Oil-Water Heat Exchanger

Vehicle Type: **Boxster**

Concerns: **Engine M96/20:**
 - **oil-water heat exchanger,**
 - **coolant vent tube,**
 - **oil pump with coolant guide housing.**

Situation: **Modified oil-water heat exchanger.**

Bild...Figure...ill...figura...fig...1

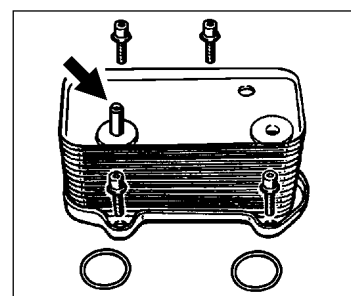
Modification: - The two flanges were omitted on the **heat exchanger**.
 The corresponding bores for the flanges are no longer present on the crankcase.
 The sealing function to the crankcase is performed by O-rings.
 A new feature on the top side of the heat exchanger is the connection point for the coolant vent hose (Figure 1, arrow).

Bild...Figure...ill...figura...fig...2

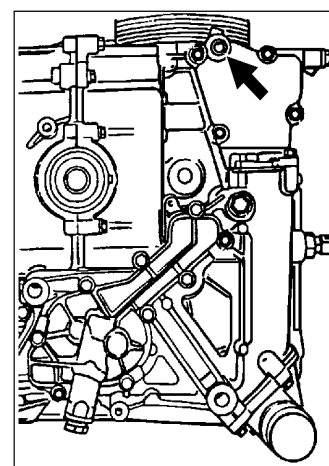
- The steel **vent tube** previously connected to the coolant guide housing has been omitted.
 A new feature is the **vent hose** connected to the oil-water heat exchanger.
 The vent hose is routed around the starter to the connection hose of the expansion tank.
 It is fastened on the connection hose with a hose clamp as previously.
- The bore for connection of the previously used vent tube on the **coolant guide housing** has been omitted.
 In the transitional phase, the bore was sealed with a pressed-in plug (Figure 2, arrow) on engines with new vent hose.

Bild...Figure...ill...figura...fig...3

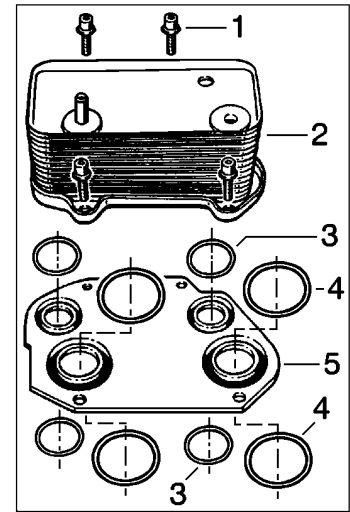
When the engine is converted to the new version, a plate is **additionally** required between the crankcase and oil-water heat exchanger (Figure 3, Item 5).

* Sealing plug: The bore for the vent tube on the previous coolant guide housing must be sealed. For this purpose, press the plug into the bore from the outside of the housing.
